Planning Commission Vote Report

Meeting Date: March 10, 2014

Petition: **P.Z. 16-2013 Wilmas Farm (17508 Wild Horse Creek Road)**

Wilmas Farm
Chesterfield, Missouri
PRELIMINARY DEVELOPMENT PLAN

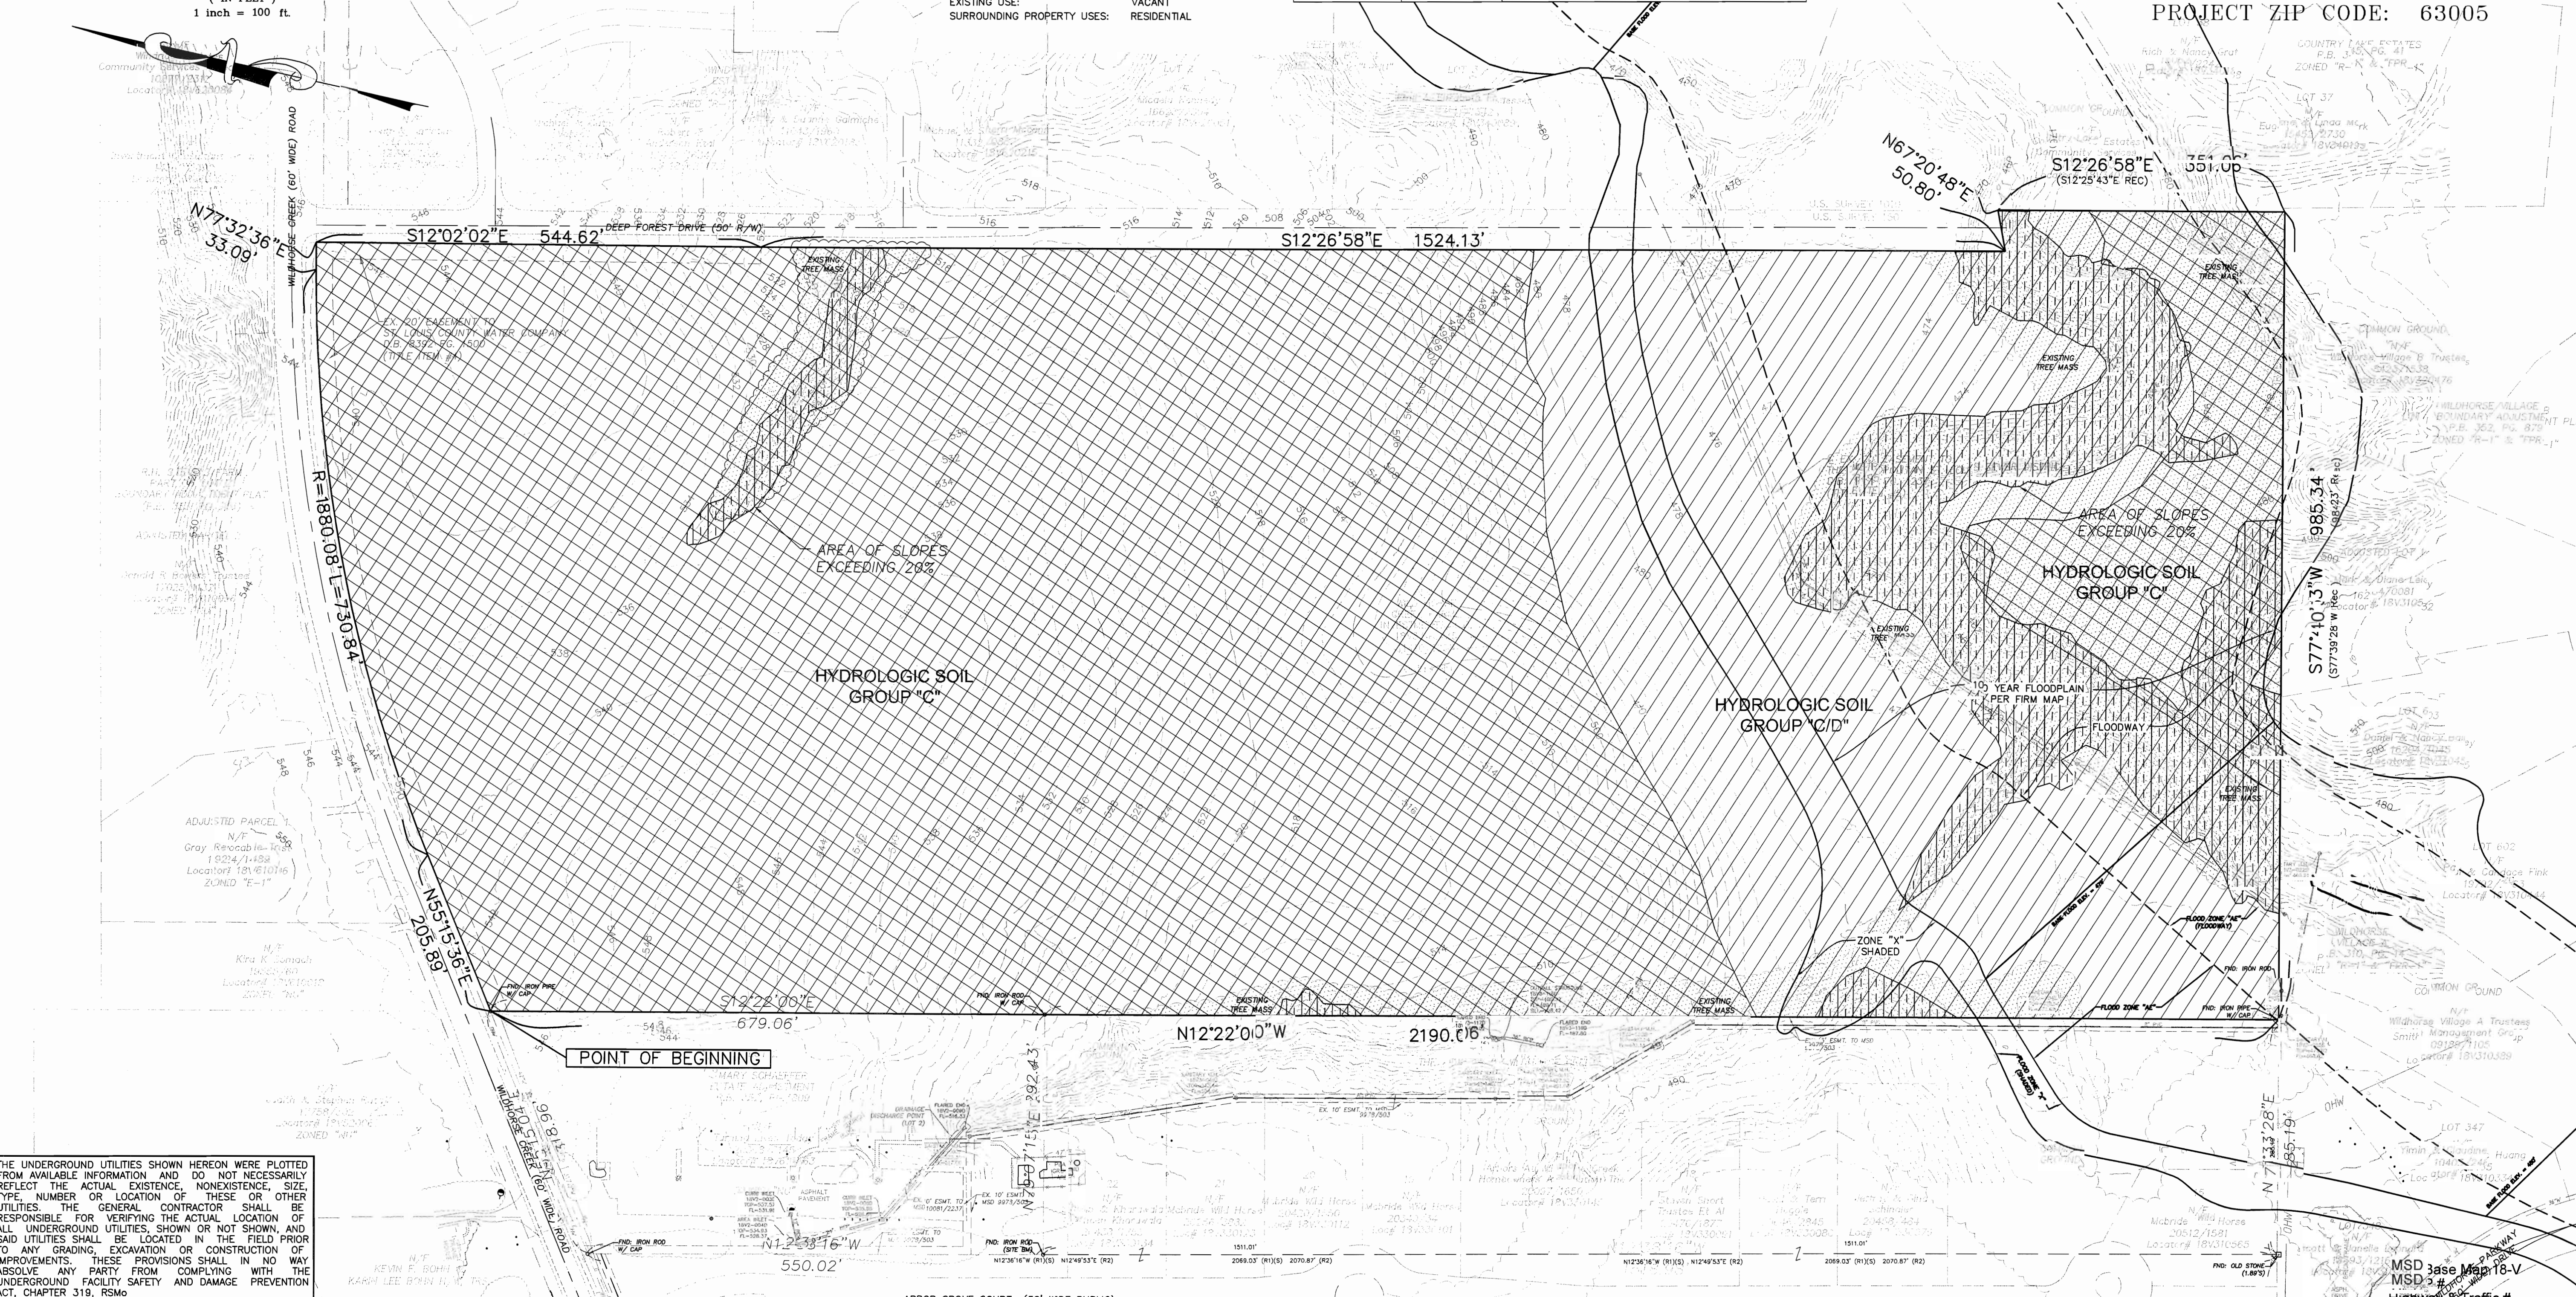
4. The development still does not provide two (2) full public access points. Amend the Preliminary Plan to show two (2) public access points to the development.

5. Amend the Preliminary Plan to show Storm Water Control Easements(s) outside the required thirty (30) foot PUD perimeter buffer.

6. The length of the proposed cul-de-sac(s) as shown on the Preliminary Plan still exceeds the maximum length for a cul-de-sac required in Section 1005.180 of the City of Chesterfield.

11. The Response Letter submitted on December 23, 2013 references a walking trail around the proposed lake, which is shown in Common Open Space. Clearly depict the trail on the Preliminary Plan.

12. Additionally, the Response Letter references amenities, such as a gazebo and wildlife observation stations, in conjunction with the walking trail. However structures cannot be erected in areas dedicated as Common Open Space.

Both the Comprehensive Plan and City Code recommend but do not require two (2) access points for the benefit of emergency vehicles. Petitioner believes this recommendation has been satisfied by the proposed secondary emergency access shown on the Revised Plan. Constructing a full access at Wild Horse Creek is problematic due to two factors, i.e. the existence of a water main and the fall off in grade from Wild Horse Creek Road. Relocating the main is not feasible, and the limit on fill above the water main makes a full access entrance not feasible. In addition, using Deep Forest Drive as the full access avoids another curb cut on a curving portion of a busy State Highway.

This has been addressed in the Revised Plan.

This has been addressed in the Revised Plan.

This has been addressed in the Revised Plan.

Petitioner will not erect structures in areas depicted as Common Open Space except for the pavilion in the centrally located one acre garden area shown on the Revised Plan and benches along the riparian trail shown on the Revised Plan. If this is not in accord with City policy, Petitioner will submit a separate letter request with justification for allowing these amenities.
